AKH OUTWEAR LTD.

1. Building Information

2. Observation

Observation-02: Mismatch in as-built drawing. (Production Building-1)

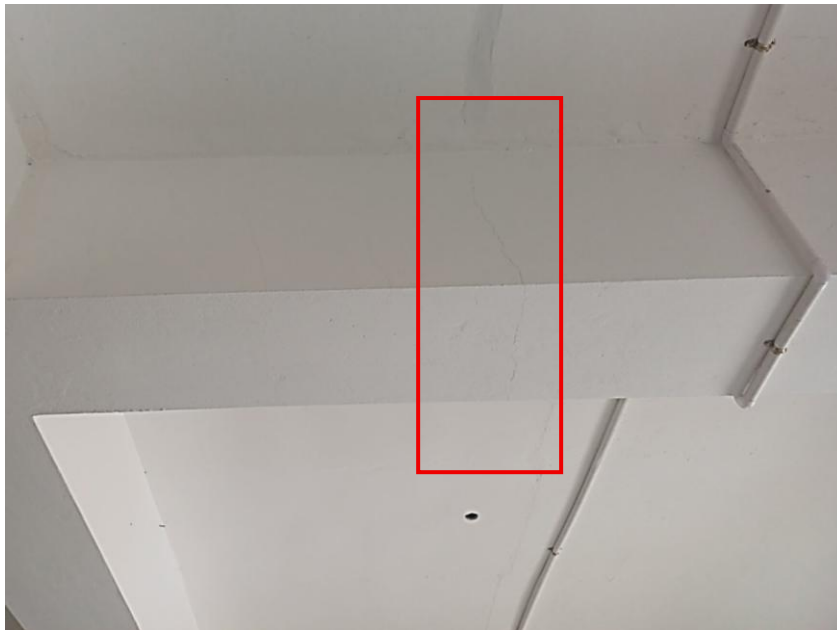
Column Schedule				
	1st Floor & 2nd Floor	Ground & 1st Floor	2nd Floor & Roof	Typ Details
C1A				
C1B				
C2A				
C2B				
C3				
C4

Description: Amount of rebar in C3 column does not match with onsite condition. 5 nos of rebar were found instead of 7 nos on each face. Building engineer is required to confirm the amount of rebar of each column and prepare accurate as-built drawing.

3.	Design report required to be reviewed by RSC against lateral loading. (Production Building-1)	Implement floor loading plan.	within 6 weeks
4.	Mismatch in as-built drawing. (Production Building-1)	Building engineer is required to confirm the amount of rebar of each column and prepare accurate as-built drawing.	within 6 weeks
